AGENDA
SPECIAL ARCHITECTURAL REVIEW BOARD MEETING
Public Meeting Room, Village Hall
Wednesday, June 1, 2016
7:00 p.m.

3.1 Continued Review of Site Design, Landscape Plans, Building Elevations, Exterior Lighting, Parking, Exterior Signage and Site Amenities for Proposed Redevelopment of the Former Cubby Bear Property for a Banquet Hall, 21657 and 21661 Milwaukee Avenue (Trisha Bumpass & Standard Bank & Trust Co.).

LOFT 21 - PROPOSED EVENT VENUE

(WITH REVISIONS PER ARB FEEDBACK FROM MEETING ON MAY 17, 2016)

**PROPOSED LANDSCAPE PLAN**
 1" = 50'-0"

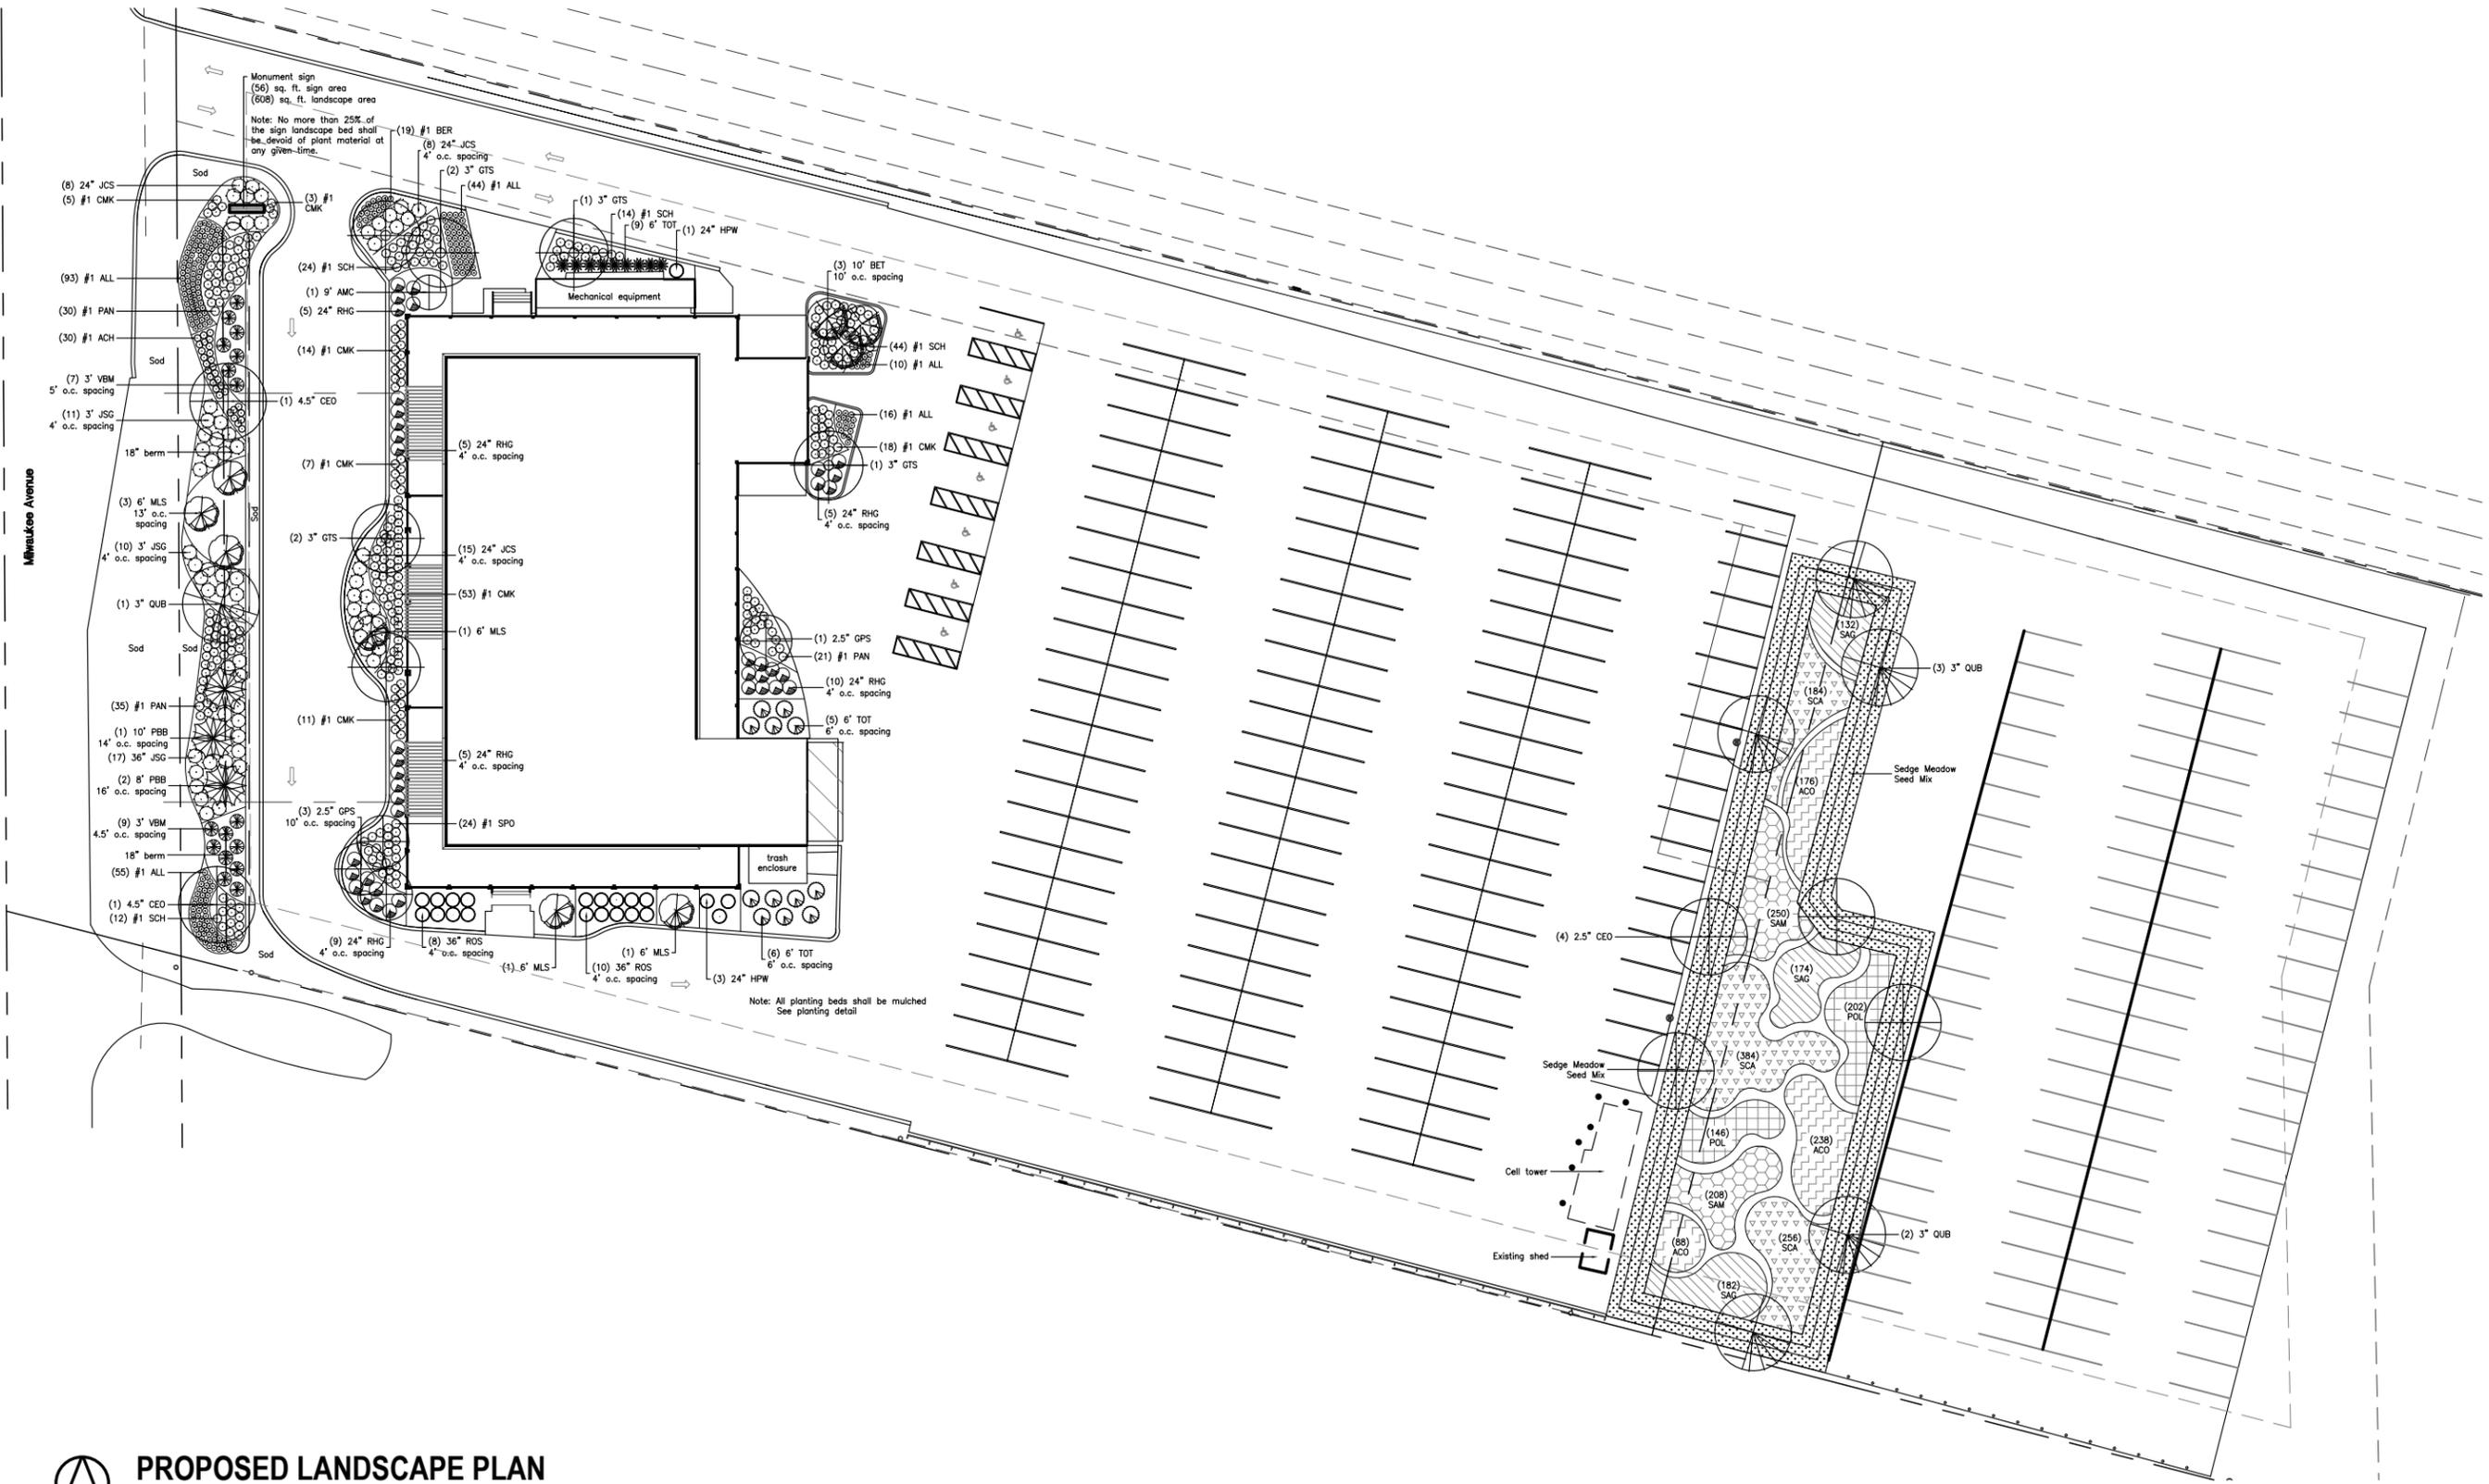
Chairman Grover requested comments from the Board with regard to the landscaping. **Member Kennerley** requested clarification of the landscaping along the front building and requested different elevations of height between the grasses and shrubs. With regard to the berm, she also suggested plantings to soften and feather some of the evergreen and tree heights. **Member Baskin** suggested using landscaping as a way of shaping a space by using groupings of plantings along the front area to enhance the scale or adding interesting specimens as focal points. It can also be used as a textural change to take you to the entrance. With regard to the berm, **Chairman Grover** inquired as to the extent of screening. **Mr. McCallum** responded the intent is to articulate with three continuous layers of evergreens and shrubs, with a beginning vertical height ranging from 6’ to 16’ and at maturity reaching upwards from 20’ to 55’. A mix of assorted evergreens, ornamental trees, and shade trees is proposed. **Mr. Gulatee** suggested incorporating birch trees if permitted.

Economic Development Coordinator Zozulya noted the lack of landscaping islands within the parking lot is due to the Petitioner’s request for a legal non-conforming variation to maintain as many parking spaces as possible on the site. **Mr. Kozlowski** explained the building can legally occupy 2000 and by zoning ratio standards, the number of the existing 255 parking spaces is far below the required amount. Discussion ensued with regard to options, to which **Mr. Kozlowski** explained the reasoning for the lack of any possibilities to increase parking or revise the parking lot layout, thus the legal non-conforming variations requested.

- Additional plant materials including a Sargent Crabapple, evergreen shrubs and grasses have been provided adjacent to the west building façade.
- The Eastern Red Cedar have been substituted with Mission Arborvitae.

- Plant materials including River Birch, Little Bluestem, Feather Reed Grass and perennials have been provided adjacent to the east building façade.
- A large landscaped island has been added adjacent to the existing porte-cochere in the parking lot to the east of the building, adjacent to the main entry to the building.

- The landscape planting has been revised along the existing west building façade to include a mixture of low-grow shrubs, as well as taller native grasses. In addition to this, we have also added a larger landscaped peninsula centered on the building façade to provide more depth to the elevation, as well as break-up the length and linearity of the façade and provide some elevational variation to the building façade. This also breaks-up the length of the pick-up/drop-off aisle into smaller segments and add more permeable material to the site for storm water management.

PROPOSED WEST (STREET FACING) ELEVATION

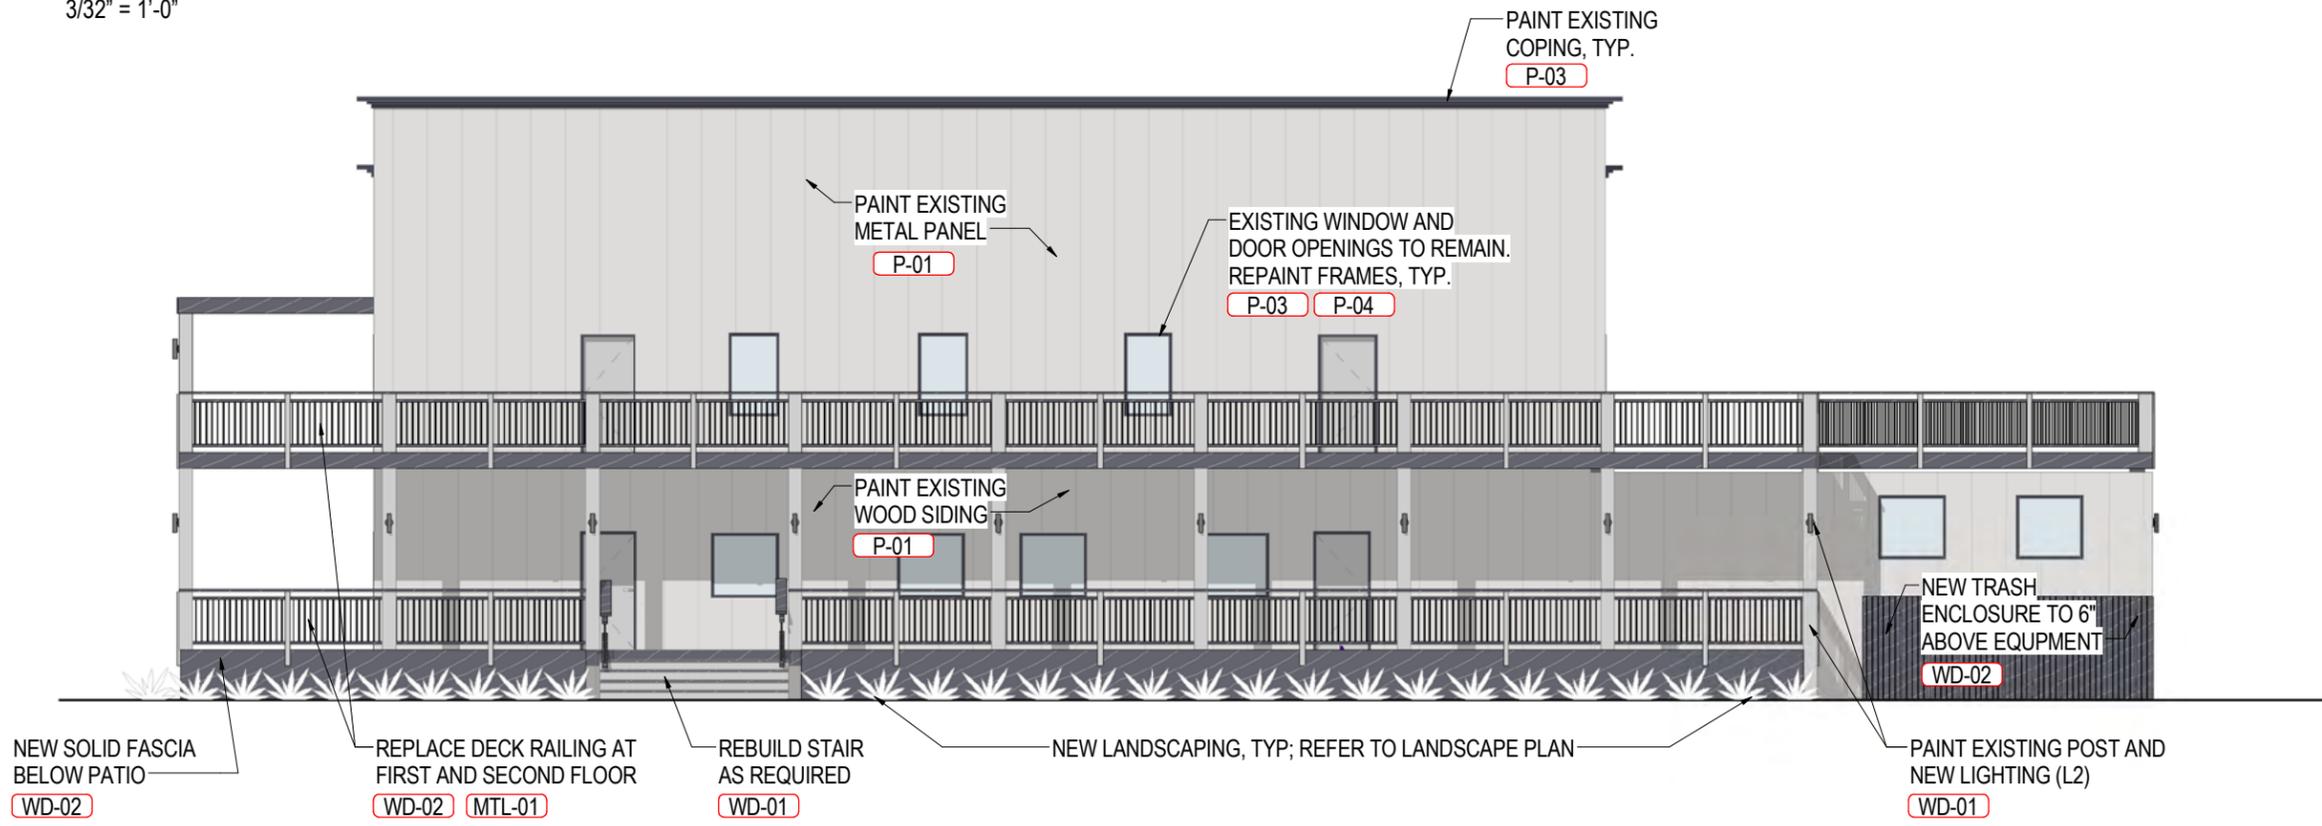
At this time, **Chairman Grover** requested input from the members with regard to the elevations. **Member Baskin** noted due to the "box" design of the existing building, he appreciates the architect's design efforts given the oddity of some of the current elements such as the cornices and the wrap-around railing. He suggested turning the design problem into something "hip" with more interest offering the use of material enhancements to the railings. Also to be considered is the entrance to the facility, as it becomes a "ceremony" of coming through the front drive around to the back of the building, coupled with the enhanced landscaping of the building front, lends itself to the "ceremony" scale and focal point. **Mr. Kozlowski** stated there are budget constrictions, but the plan is to create the procession through lighting for a warmer, approachable feel, and he welcomes more discussion with regard to the design elements. He also noted that a drop-off aisle has been incorporated across the front of the building.

Member Gulatee noted the opportunity to do something interesting, and expressed his agreement with Staff for the need to have articulation in the facades. He suggested converting the entire front area of the building into a front court with benches, lighting, and landscaping for people to enjoy and be seen from Milwaukee Avenue. He noted the south side of the building has the service yard appearance with the trash enclosure in place, and moving the hvac equipment from the north side to the south side, would provide the opportunity to combine the north and east side/corner area as the main entry, as well as relocating the drop-off aisle and the porte cochere in the same vicinity. With regard to the facades, **Member Gulatee** noted articulation through the use of panels to reflect some activity on the inside and centering glass on the front elevation, connected with ramping leading downward to a front paved garden court.

Member Kennerley pointed out that the removal of the wooden railing and incorporating black railing or wrought iron or other black elements will change the character of the appearance, whereas wood softens and gives a “homey” look. She agrees with **Member Gulatee** with regard to the suggestion of a front yard area to attract people, as the bulk of the activity is on the back side of the building. **Mr. Koslowski** added that the intent is for an industrial building in form, however, the wood serves to soften and warm in coloring.

Given the building design challenges, **Chairman Grover** questioned the purpose of the front drive/drop-off aisle, because he felt the suggestions for a front landscaped court area would add to the appearance. Further, he sees no opposition from the members to a more modern design for the building to which **Mr. Koslowski** responded favorably to move forward with revisions to embrace and entertain the industrial side of the building and taking it to a modern twist. **Member Gulatee** added there is the option to not follow the outline of the previous balconies and consider a cantilever out design.

PROPOSED PERGOLA AND RAILING DETAIL - FRONT
1/4" = 1'-0"

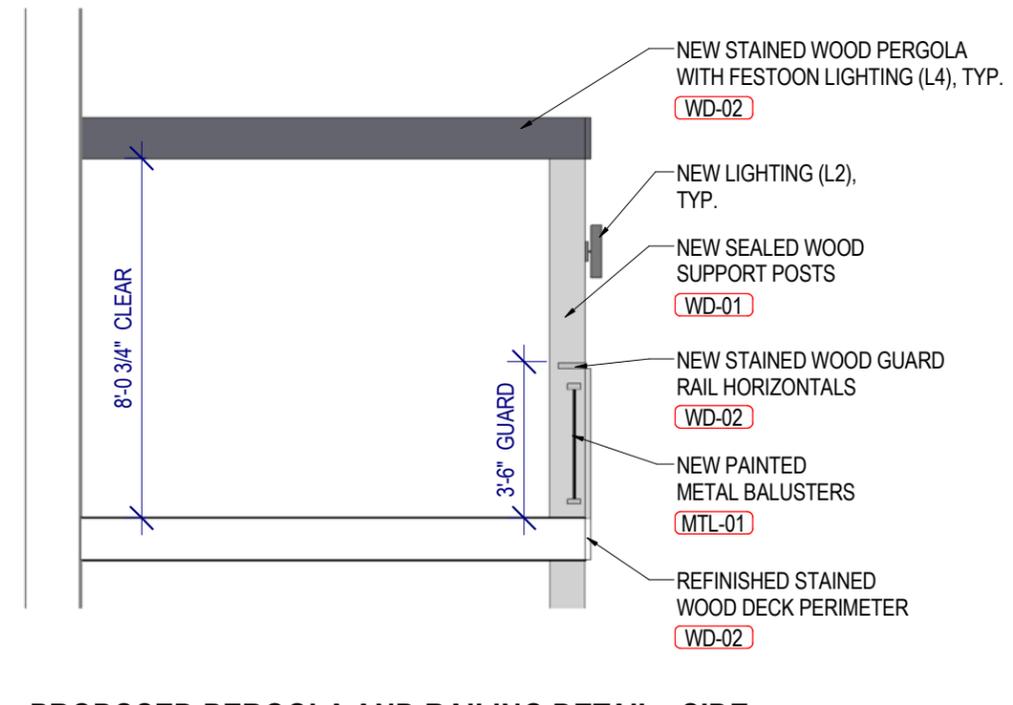
Member Jensen agreed somewhat with Member Gulatee's comments. He thought the proposed building concept looks good albeit it has an industrial appearance. He is concerned with the wood deck element that may or may not fit the building and suggested creating more dimensions with landscaping to warm or compliment the wood. **Mr. Kozlowski** expressed his desire to work with some of these suggestions and explained that the use of panels did not provide enough depth or shadowing, and thus, the trellises, balconies, and railings were created. He offered using glass doors in lieu of the existing metal doors, and sees the opportunities suggested and would entertain these ideas while keeping in line with the budgetary constraints.

- The revised detailing of the proposed railing on the existing first and second floor balconies has been revised based on the comments from the ARB to go a more contemporary route with regard to color,

finish, form and materiality. The vertical balusters are now an accent metal while the main vertical supports are an accent stained wood, with main horizontals to match.

- The proposed trellis along the west façade has been updated so the perpendicular horizontal elements have been recessed within the main border ledgers for a more contemporary detail. The proposed festoon lights have also been tightened up so there is slightly less slack in the cord to provide less draping of the lights. The stain color of the wood trellis has also been updated as shown in the revised rendering and design package.
- The existing cornice coping at the top of the existing building parapet has been updated to include a new, cooler, darker finish to match the new cooler, more contemporary colors being proposed on the revised building proposal.
